80C186EC/80C188EC AND 80L186EC/80L188EC EMBEDDED MICROPROCESSORS SPECIFICATION UPDATE

Release Date: June, 1997
Order Number: 272898-002

The 80C186EC/80C188EC and 80L186EC/80L188EC microprocessors may contain design defects or errors known as errata which may cause the products to deviate from published specifications. Current characterized errata are documented in this specification update.

Figure 1. NMI Ignored During HLT Entering Powerdown

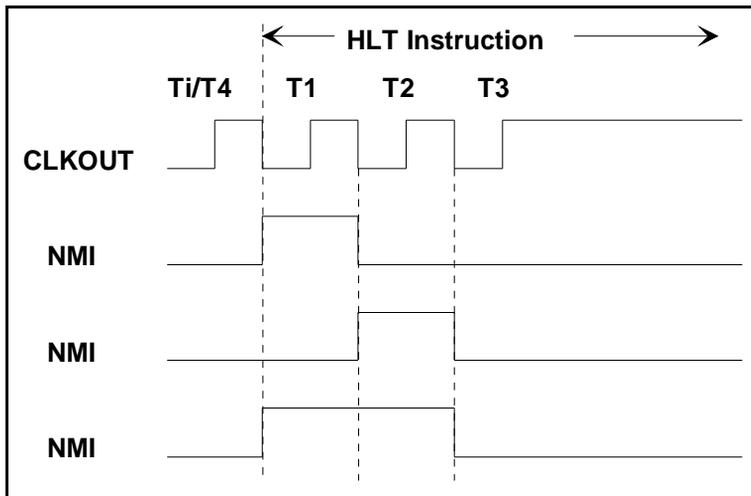
PROBLEM: If an NMI can be received during execution of the HLT instruction when entering Powerdown mode, certain considerations must be made.

IMPLICATION: If an NMI occurs during execution of the HLT instruction when entering Powerdown mode, the processor may enter Powerdown or may not service the NMI. To avoid this, the NMI pulse width must be extended to allow recognition.

The problem occurs when an NMI occurs during execution of the HLT instruction. NMI is only serviced at valid instruction boundaries. The HLT instruction, when entering Powerdown, does not really have a boundary, it extends until Powerdown is exited. If NMI occurs between the beginning the T1 bus state and the end of the T2 state, but does not extend into T3, it will not be recognized, and the processor will enter Powerdown mode. The processor does not recognize the NMI request during the HLT instruction until the internal clock has stopped (at the end of T2).

For the NMI to be recognized during the execution of the HLT instruction, the pulse must extend into T3. At this point, the processor has entered Powerdown and synchronized the NMI pulse. The NMI will be processed, but the processor will never enter Powerdown. Essentially, because NMI is active, the processor exits Powerdown as soon as it enters.

In a typical system design using Powerdown mode, NMI can only occur after Powerdown is entered and the clock is stopped. The simplest solution to the problem is to not assert NMI unless the processor has entered Powerdown Mode.

If the system requires periodic NMI pulses, then the NMI pulse width must be long enough to ensure that it will extend into the T3 state of the HLT instruction. A NMI pulse width of three CLKOUT periods guarantees this.
